DESCRIPTIVE REPORT

Type of Survey Hydrographic
Field No. RA-40-2-96
Registry No. H-10718

State Alaska
General Locality Southwest Prince William Sound
Sublocality Southern Portion of
..... Knight Island Passage

EVALUATION REPORT

ATTACHMENT 2
 H-10718 LIMITS DEPICTED ON CHART 16702,
 9TH EDITION, JULY 21, 1990.
 LIMIT LINE DENOTES AREA OF SUPERSESSON
 SUPERSEDED AREA OF CHART
NOT TO SCALE

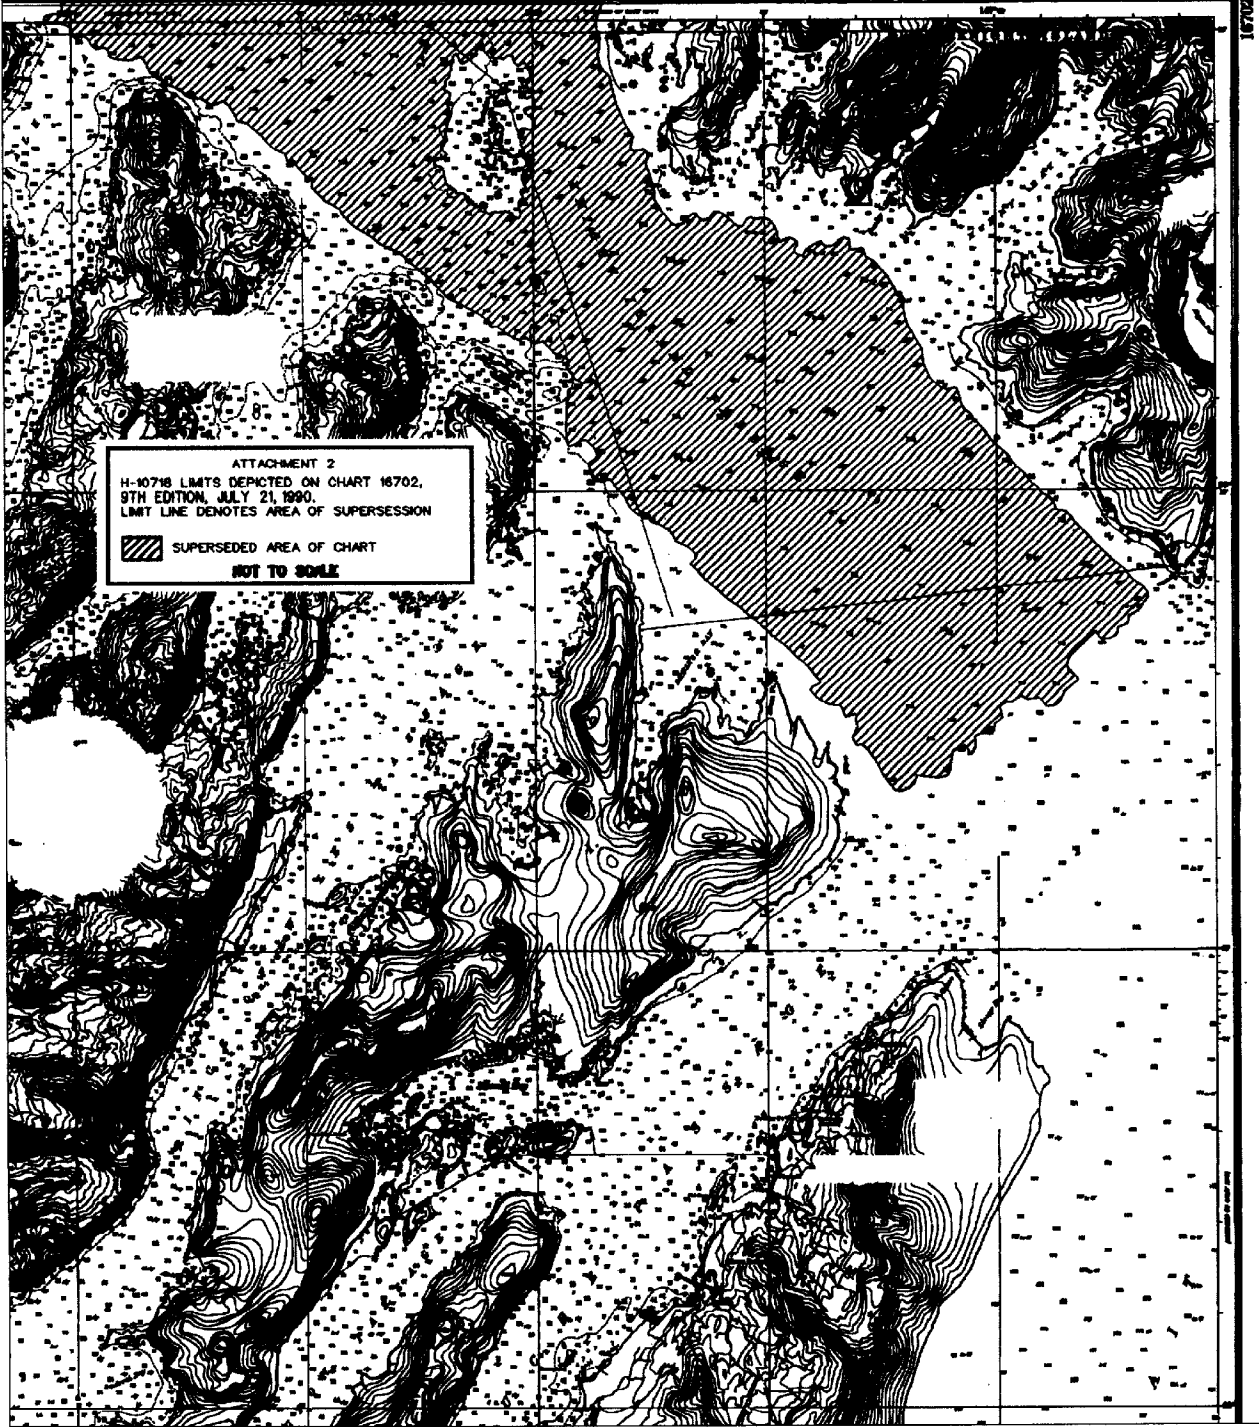
The survey area is adequately described in the hydrographer's report. Page-size plots of the charted area depicting the limits of supersession accompany this report as Attachments 1 thru 3.

Survey H-10718 is adequate to supersede charted hydrography within the charted area.
